AGENDA
La Vergne Planning Commission
June 27, 2023 at 6:00 PM

MINUTES OF THE REGULAR MEETING OF THE CITY OF LA VERGNE PLANNING COMMISSION HELD ON MAY 30, 2023 AT LA VERGNE CITY HALL, LA VERGNE, TENNESSEE.

V-1.00

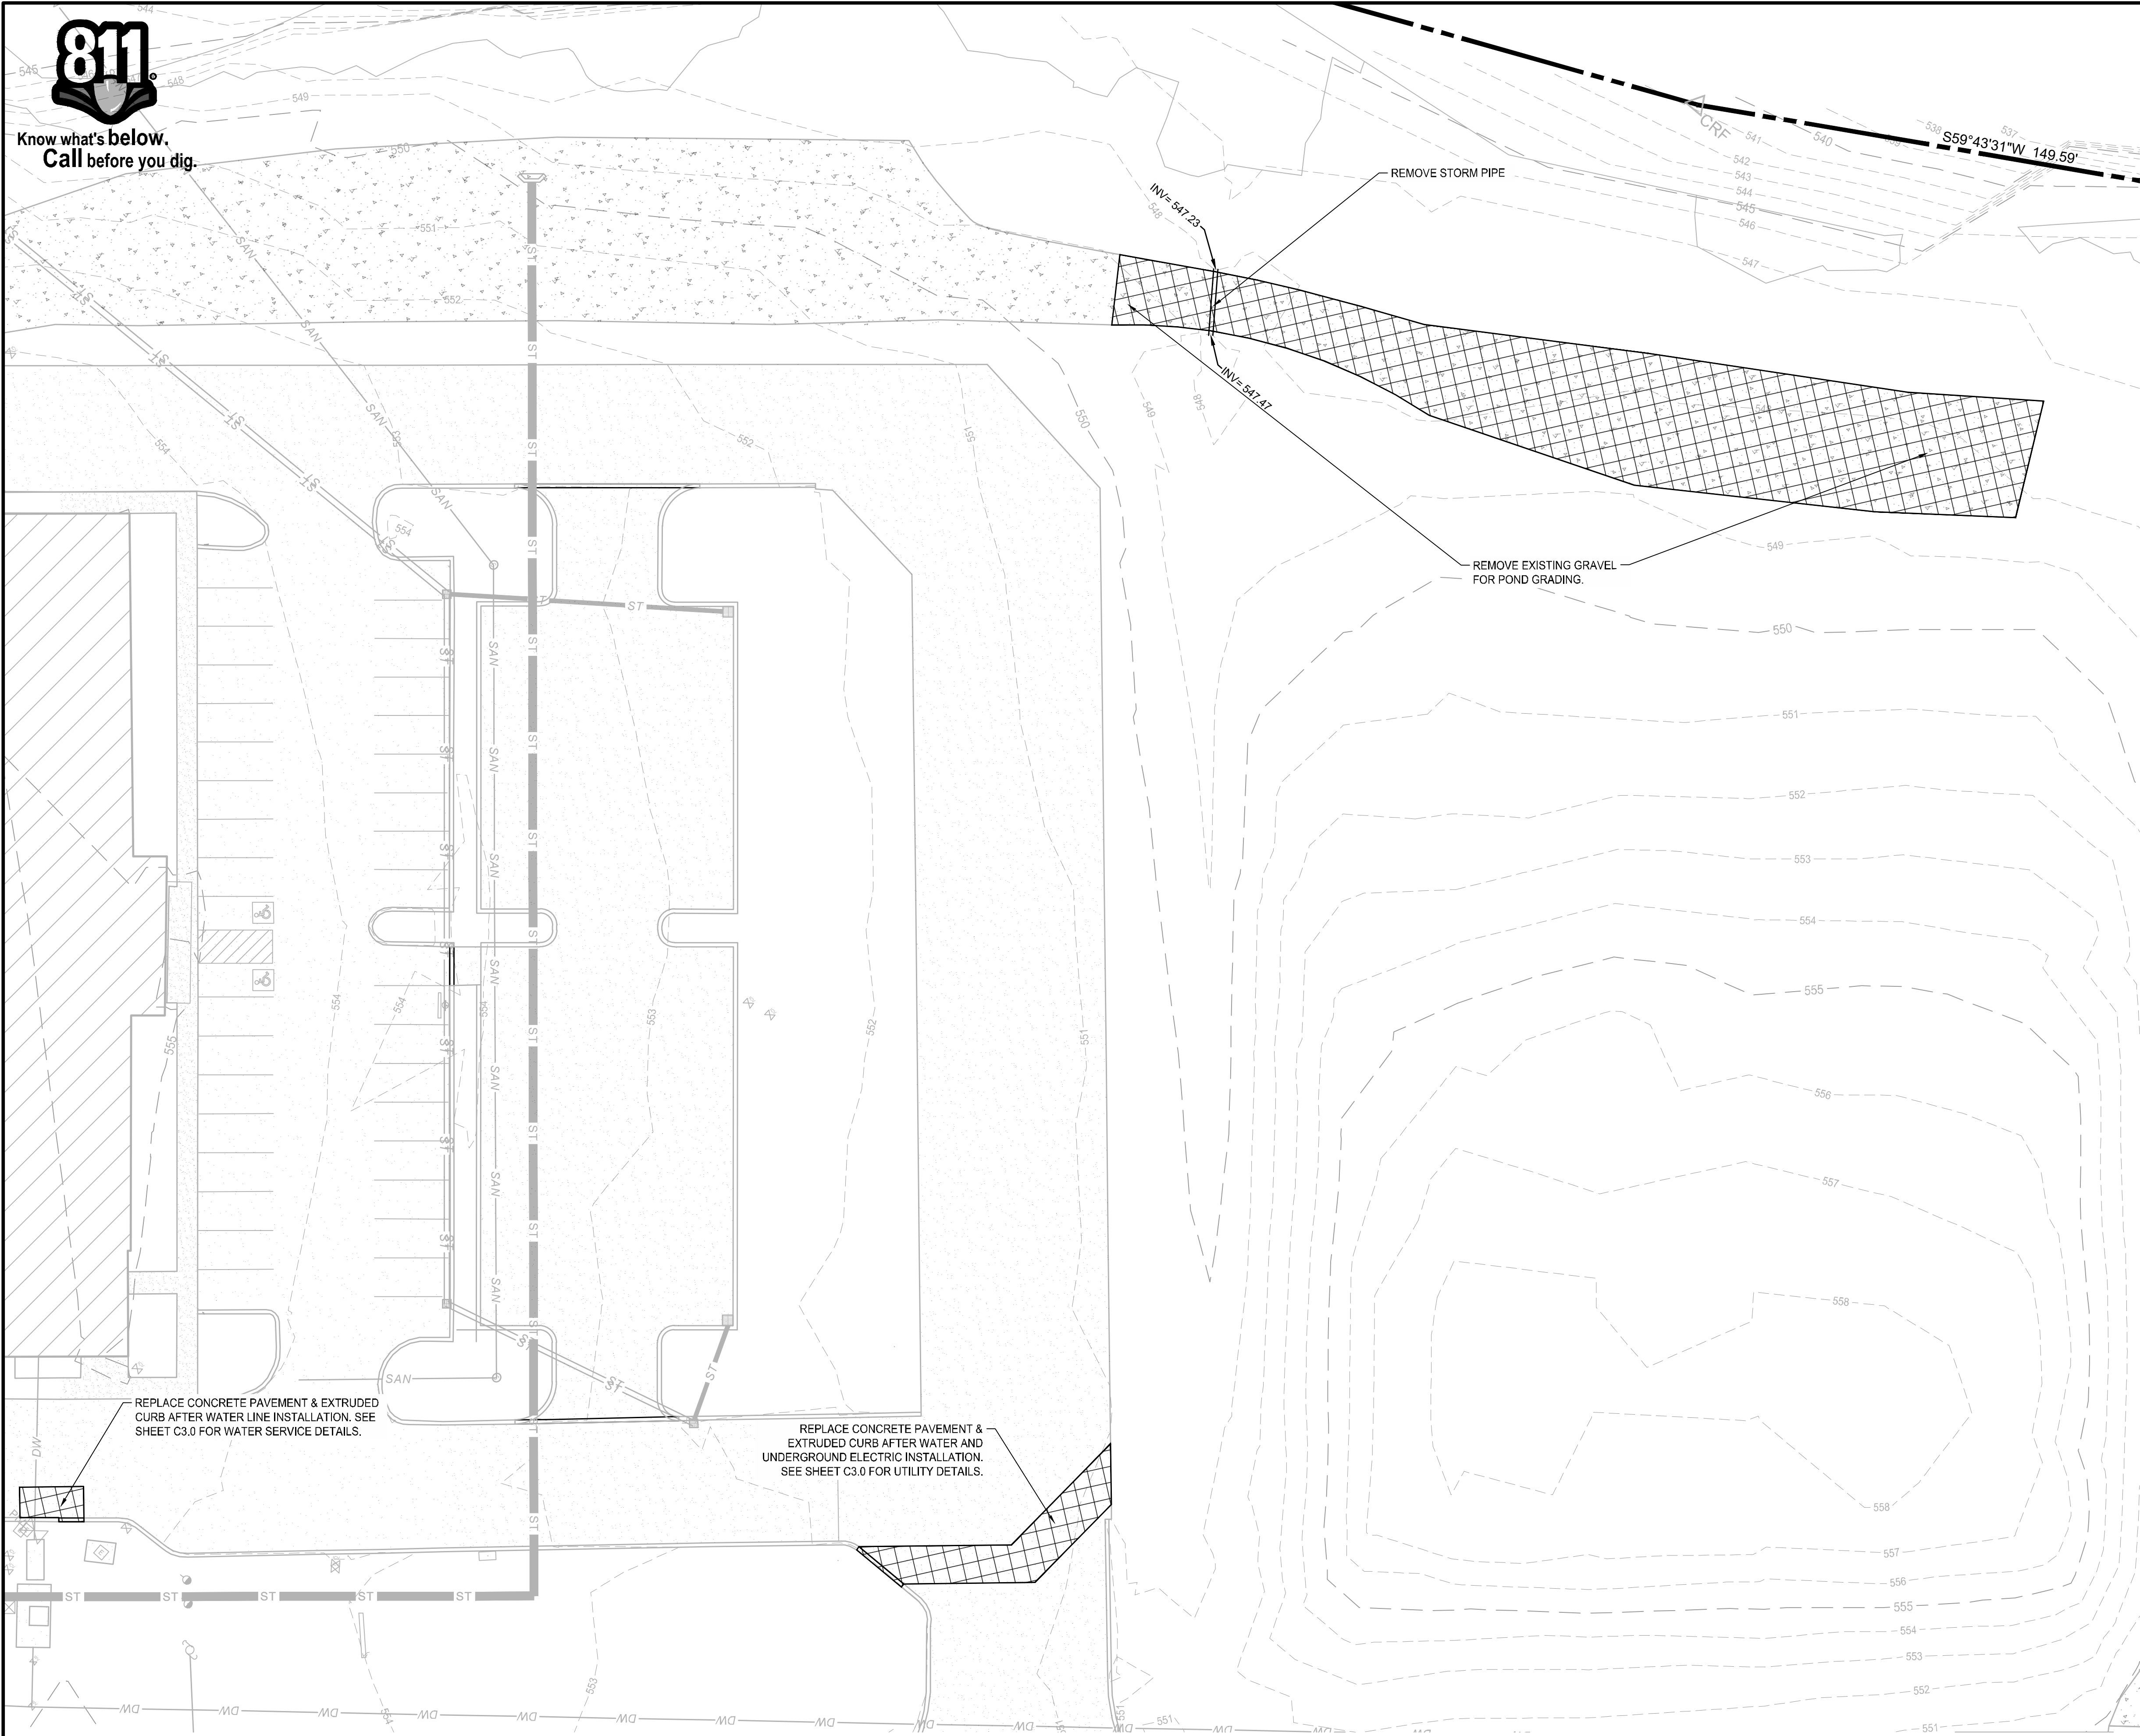
1. (Sheet V-1.00) Show bearings and distances on the overall site property line.
2. (Sheet C1.0) Locate new building from either:
 1. Existing building
 2. Property line
 3. Coordinates
3. (Sheet A-200 and C1.0) No signage is shown on the building and no directional or informational

SITE GRADING & DRAINAGE PLAN

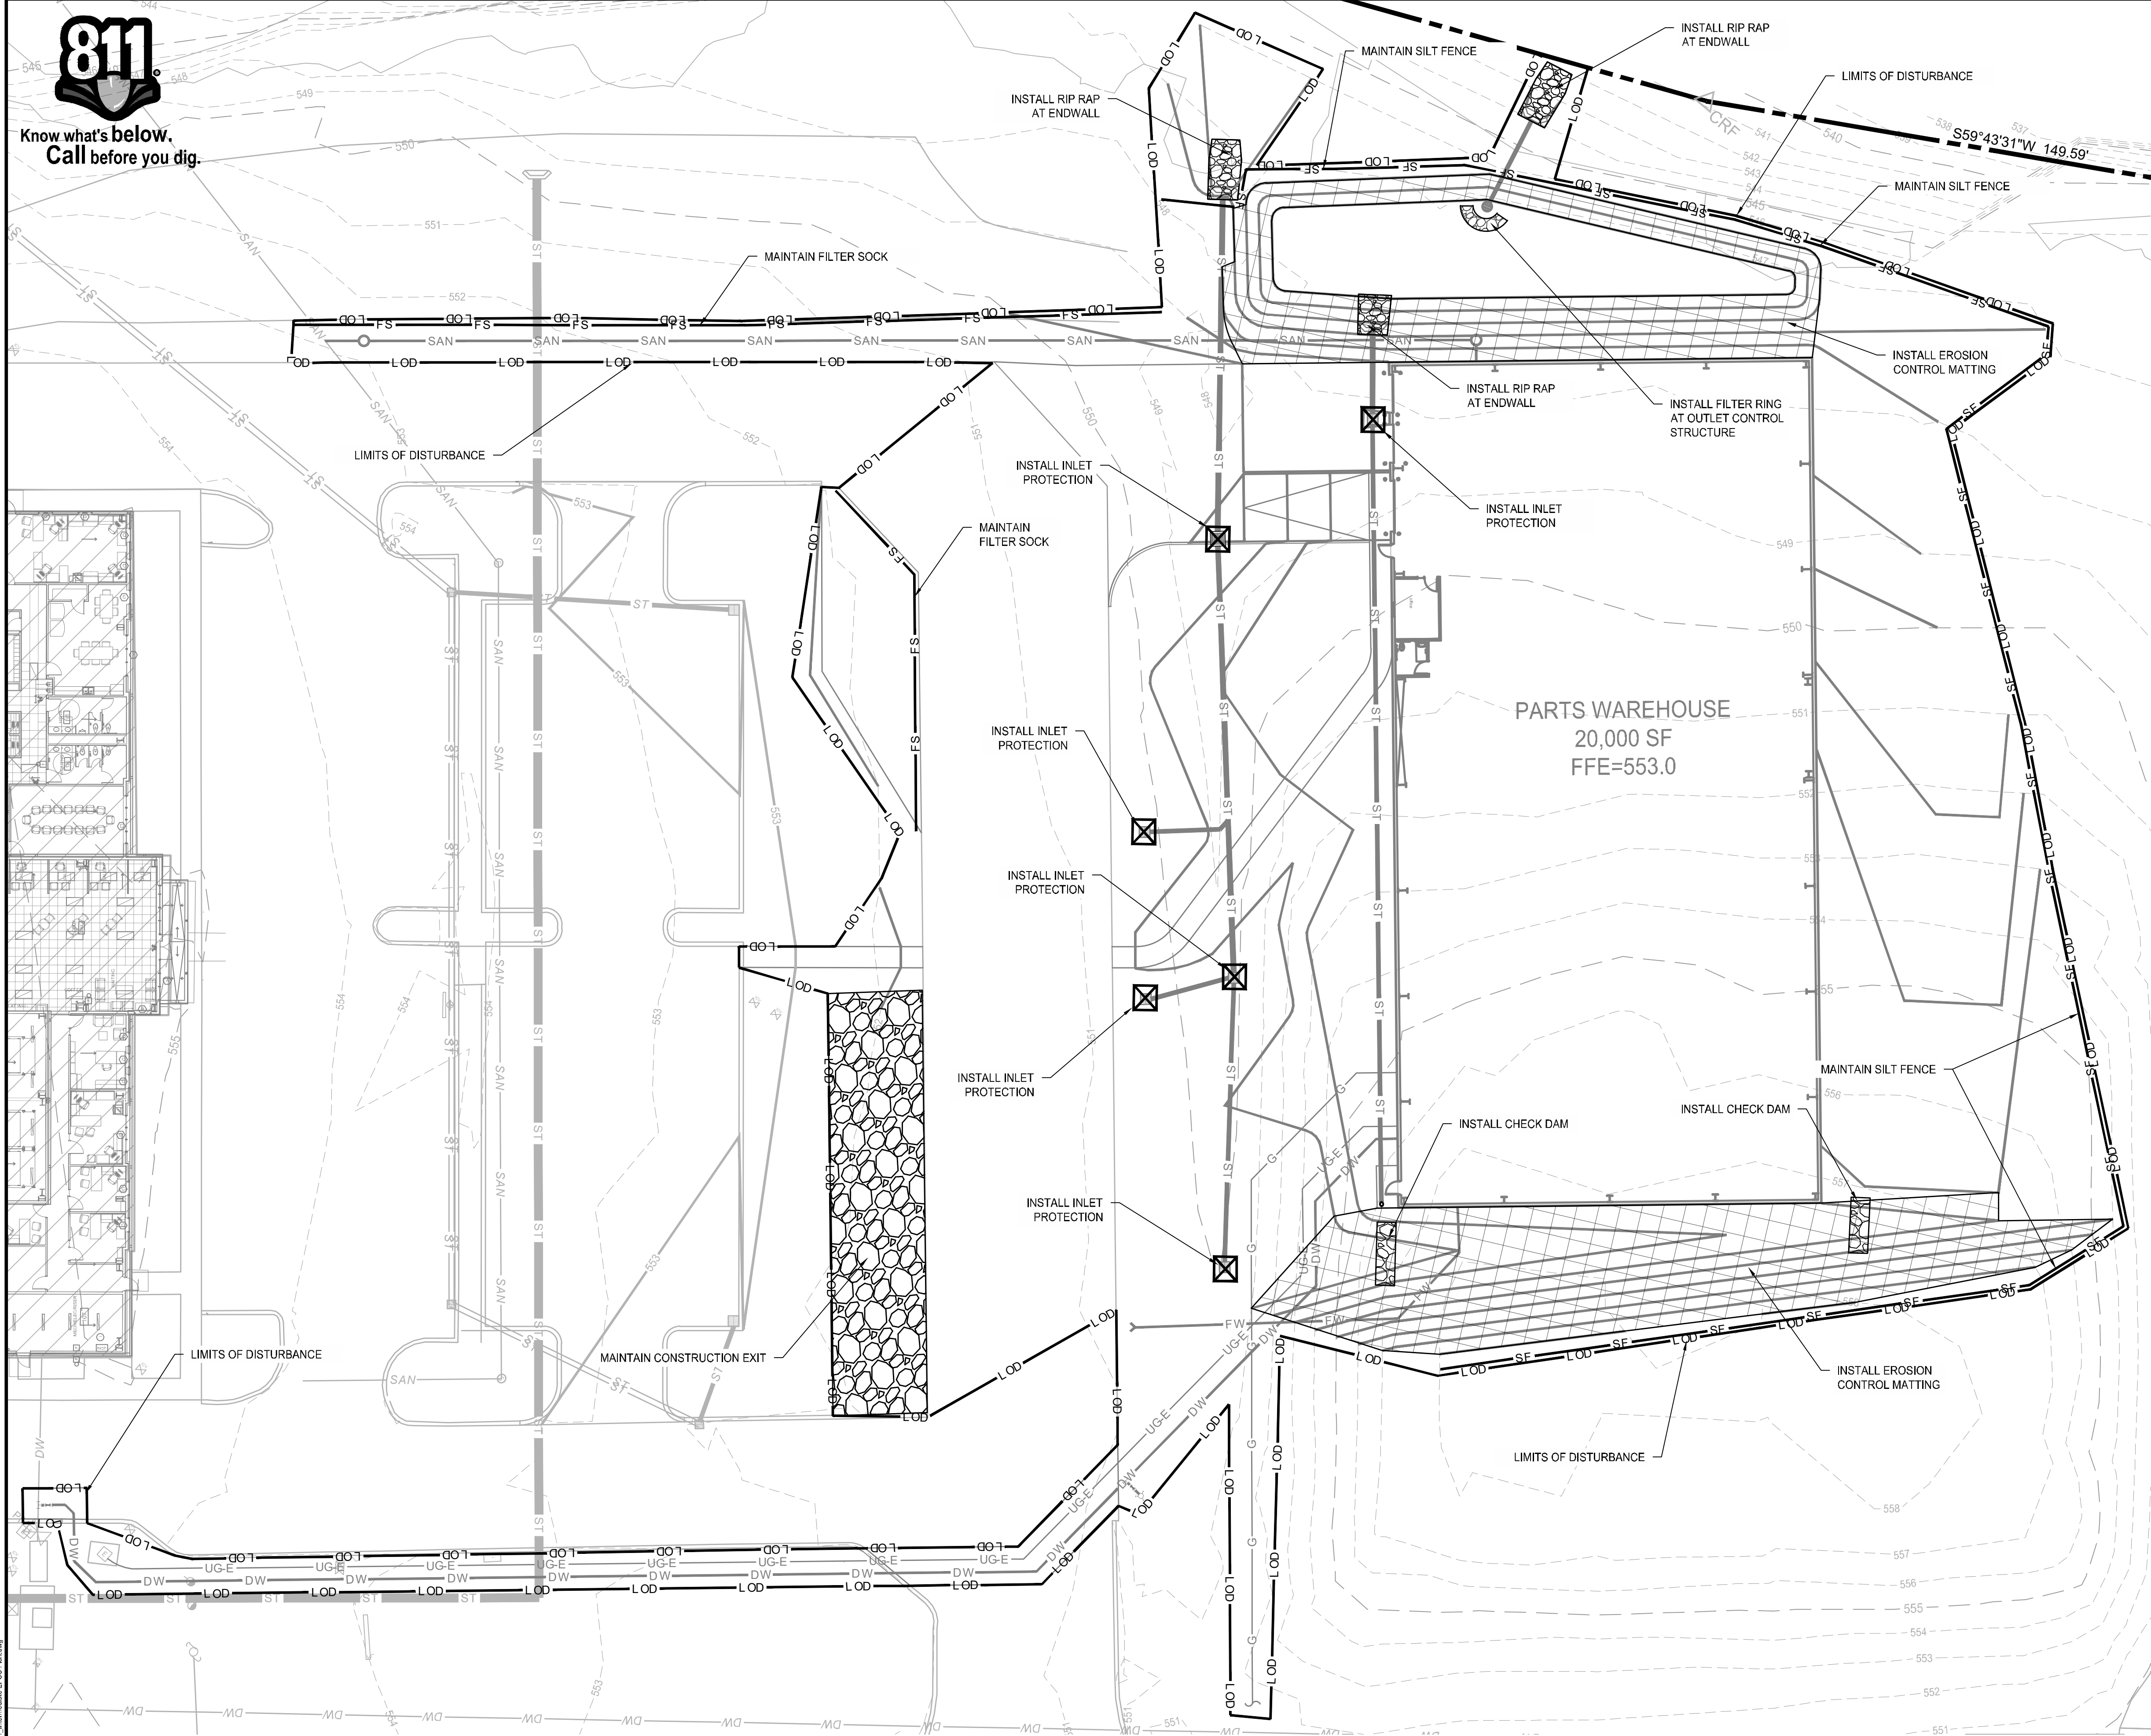
7. (Sheet C2.1) Provide silt fence or filter socks downstream of utility trench excavations.
 8. (Sheet C2.0) Change title of sheet to 'Site Grading, Drainage, and Final EPSC Plan' to bring submittal into full compliance with City Ordinance Requirements. Also, show permanent groundcover on this sheet.

INTERMEDIATE
EPSC PLAN

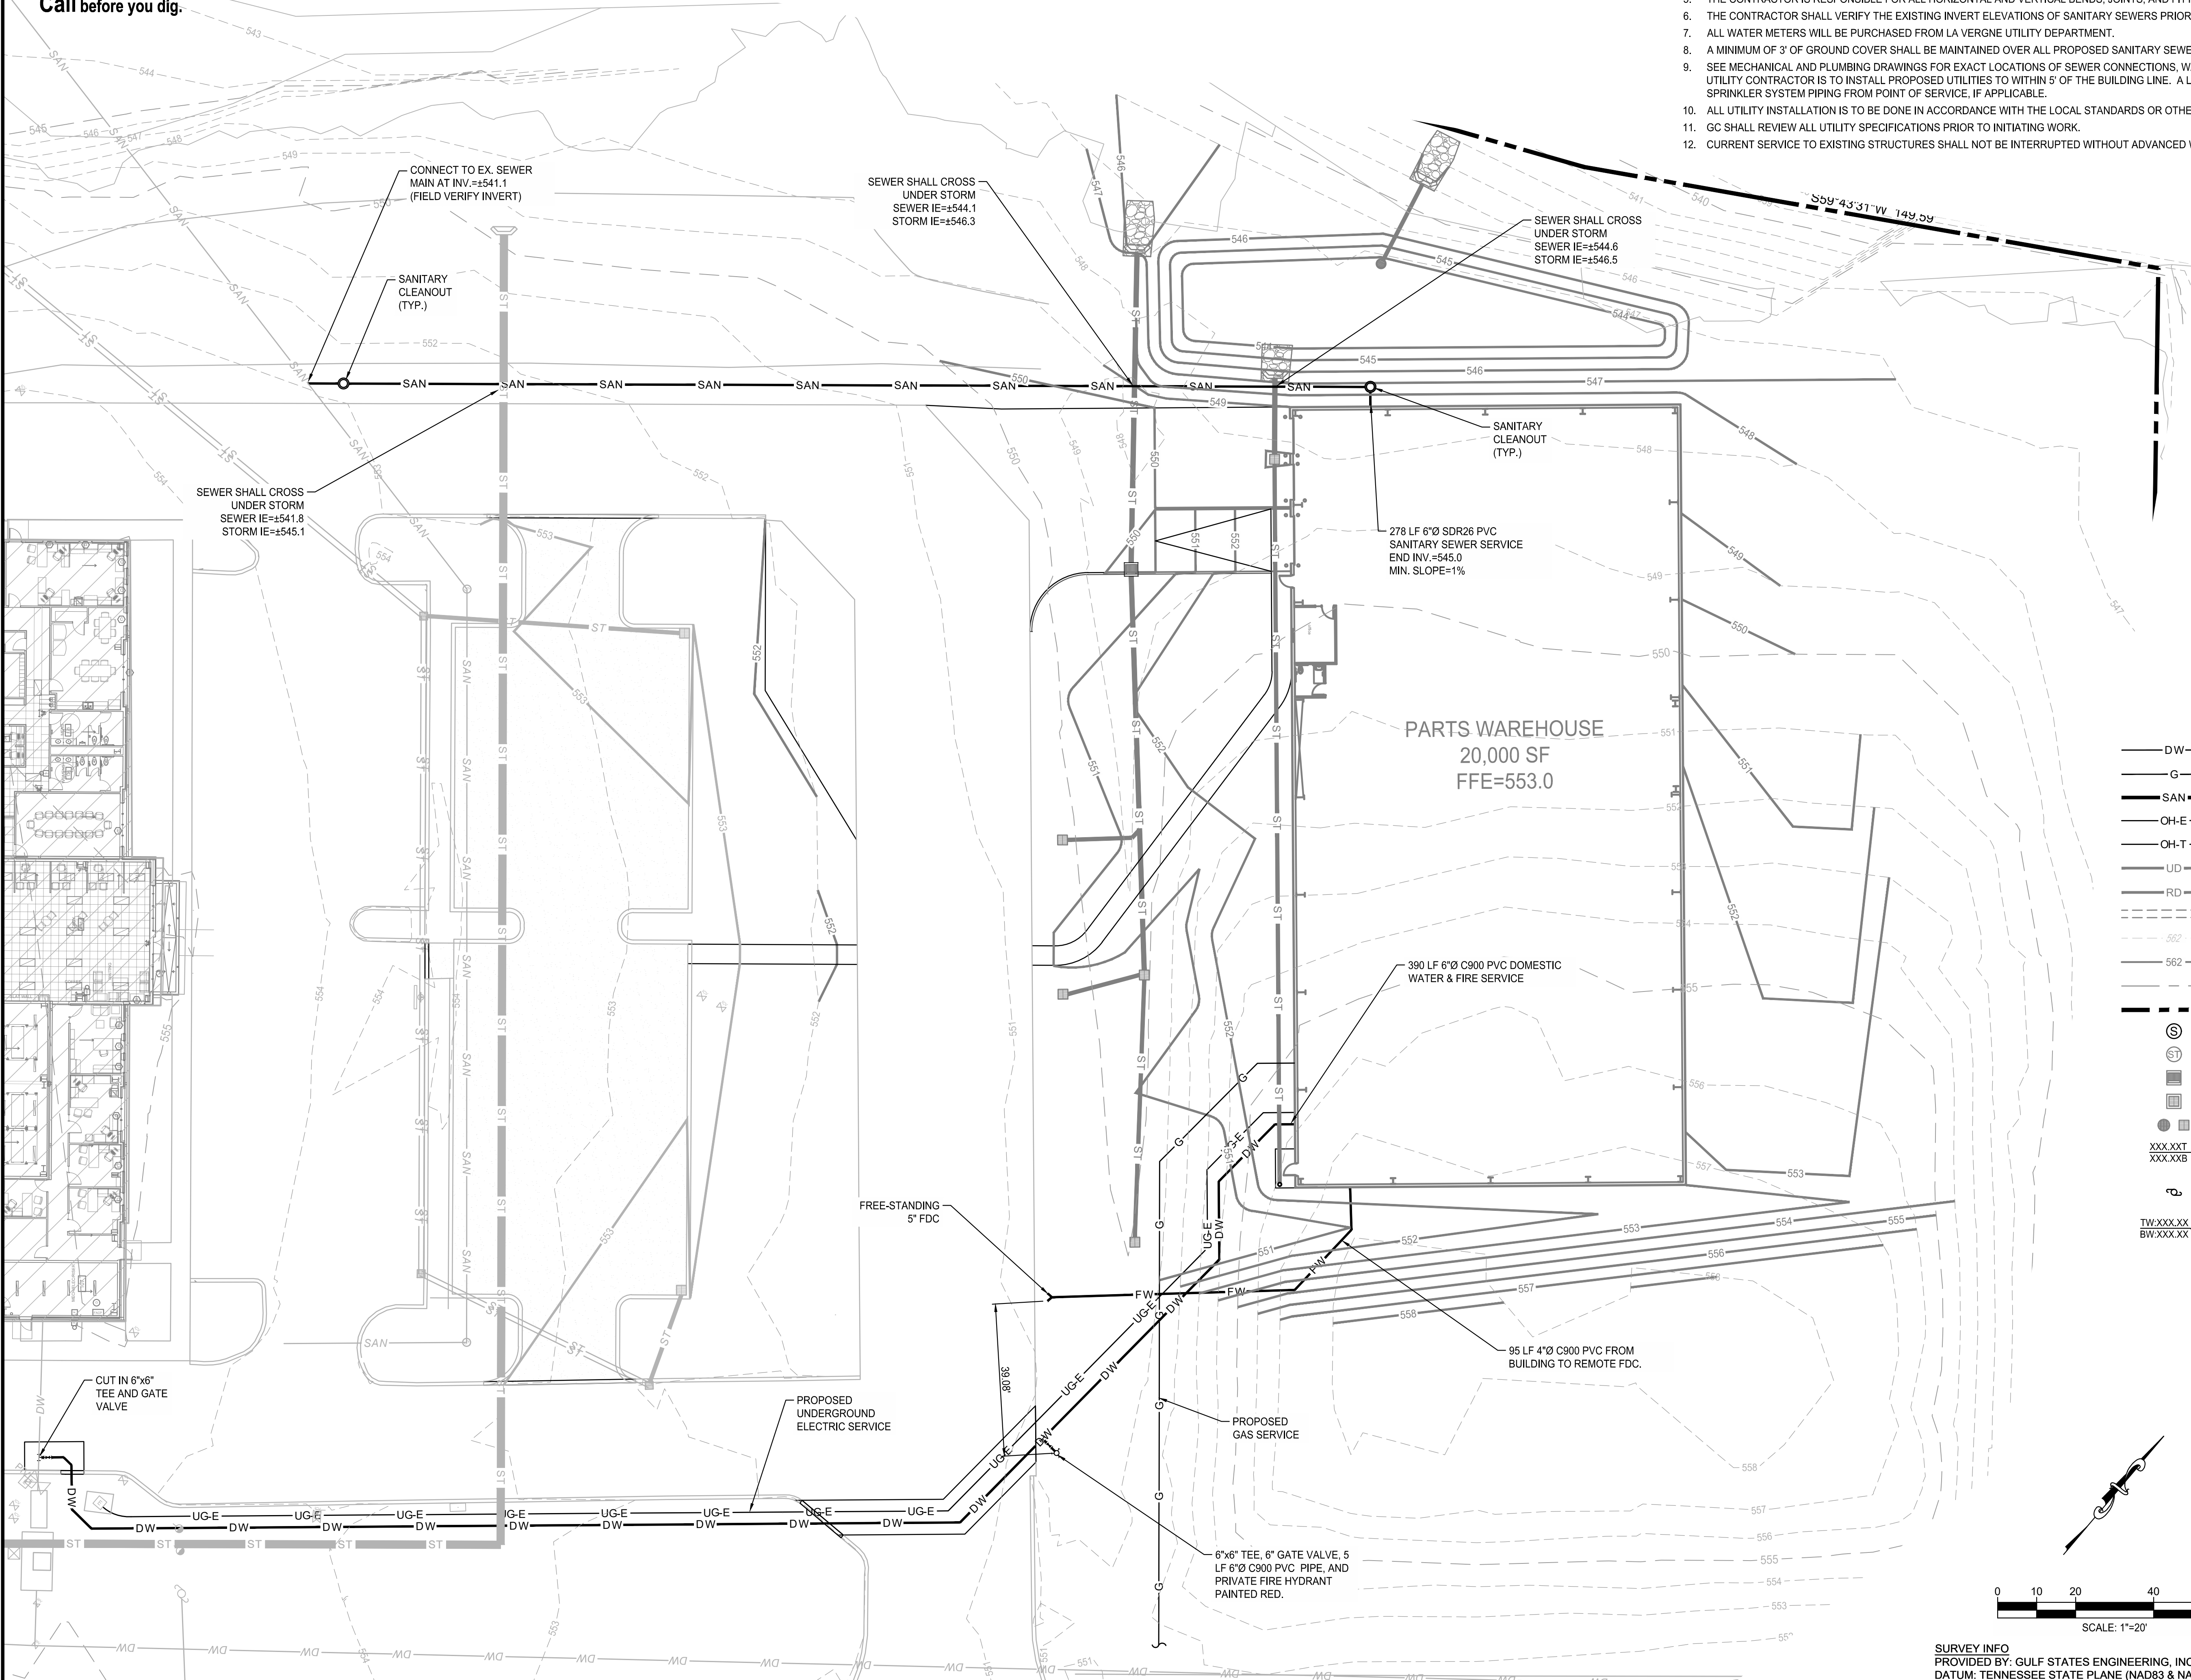
5. (Sheet C1.0) Provide details for the walk crossing of the drive which meet ADA standards.
 6. (Sheet C 0.2, C2.1, and C2.0) Show 'Stone Filter Ring' downstream from proposed pipe outfalls toward stream.
